CITY OF FORT LAUDERDALE

# DEVELOPMENT REVIEW COMMITTEE

CASE NO. UDP-S24031

<b>CASE:</b>	UDP-S24031
<b>MEETING DATE:</b>	May 14, 2024
<b>REQUEST:</b>	Site Plan Level II Review: Mixed-Use Development with 36 Affordable Housing Residential Units and 1,841 Square-Feet of Commercial Use with an Associated Parking Reduction and Height Increase in the Northwest Regional Activity Center
<b>APPLICANT:</b>	Julia Marie Gaffney, on behalf of CRA
<b>AGENT:</b>	Robert B. Lochrie III, Esq., Lochrie & Chakas, P.A.
<b>PROJECT NAME:</b>	The Aldridge
<b>PROPERTY ADDRESS:</b>	1202 NW 6th Street
<b>ZONING DISTRICT:</b>	Northwest Regional Activity Center – Mixed Use west (NWRAC-MUw)
<b>LAND USE:</b>	Northwest Regional Activity Center
<b>COMMISSION DISTRICT:</b>	3 - Pamela Beasley-Pittman
<b>NEIGHBORHOOD ASSOCIATION:</b>	Historical Dorsey-Riverbend Civic Association
<b>CASE PLANNER:</b>	Adam Schnell

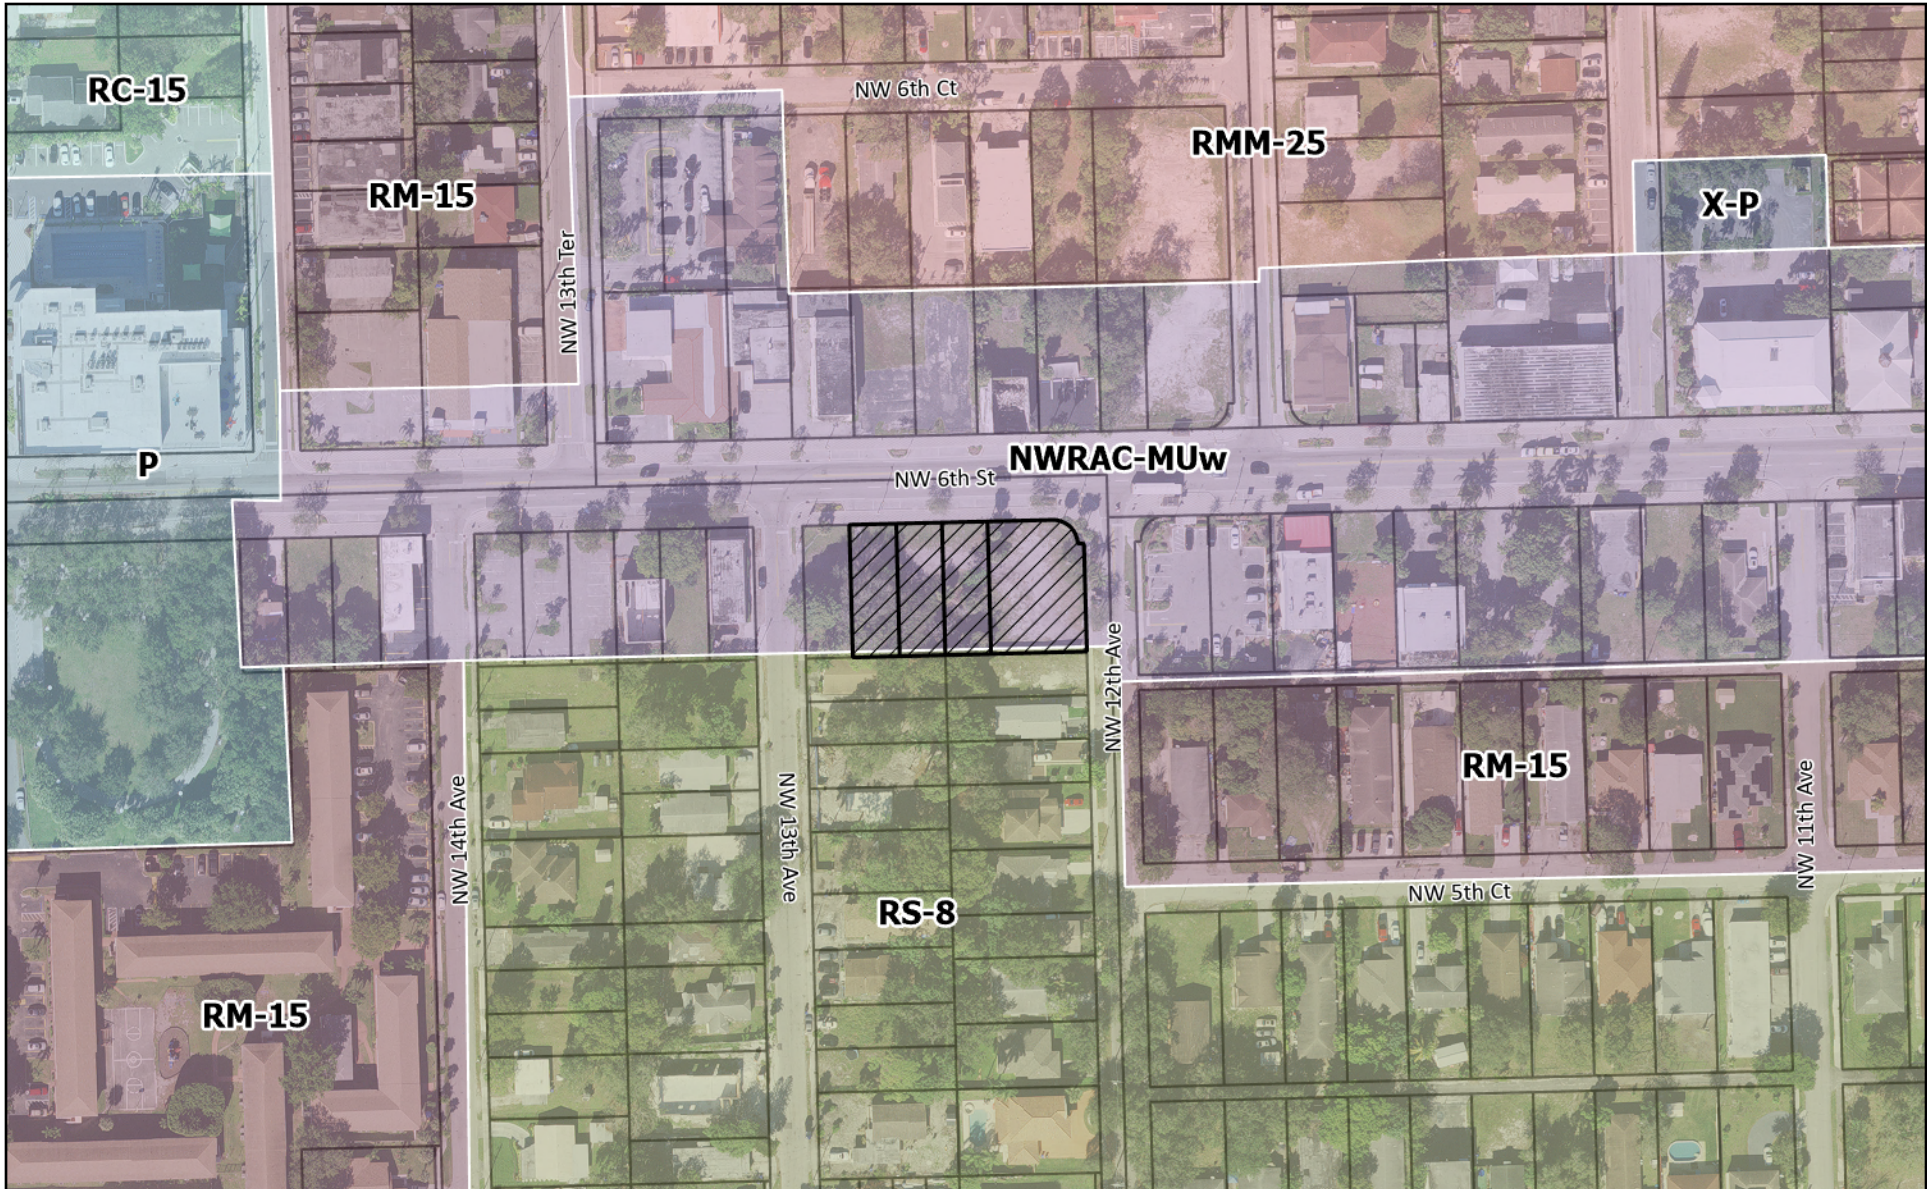
BUILDING DESIGN STANDARDS: NWRAC-MU		YES	NO	N/A	MORE INFORMATION NEEDED
	Clarification is needed on how the height of the building is being measured. The elevations show the height of the building is not measured from BFE +1				
B-9b	Maximum Floorplate: Commercial 32,000 square feet Residential 12,000 square feet	X			
B-9c	Minimum Tower Separation: 40 feet (depending on floorplate)			X	
B-9d	Minimum First Floor Height: Fifteen (15) feet	X			
B-10	Towers do not exceed minimum stepback dimensions and maximum floorplate area.  Minimum Tower Stepback Front Corner Side Rear Primary Street: 12 feet* 12 feet* Side and Rear are dependent on floorplate  Tower stepback is not being met on the front and corner tower stepback. A 12 ft stepback is required along Sistrunk Blvd and a 15ft stepback along NW12th Avenue.  Secondary Street: 15 feet 15 feet [Dependent on floorplate]  Maximum Floorplate / Minimum Tower Stepback  <u>Commercial</u> 32,000 square feet / 30 feet side and rear stepback 20,000 square feet / 25 feet side and rear stepback 16,000 square feet / 20 feet side and rear stepback  <u>Residential</u> 12,000 square feet / 30 feet side and rear stepback 10,000 square feet / 25 feet side and rear stepback 8,000 square feet / 20 feet side and rear stepback  Balconies currently encroach into the 30-foot tower stepback requirement along the rear. Balcony encroach is only permitted up to 3 feet when open on three sides. Remove wall separating to encroachment in order to allow balconies to encroach up to three feet.		X
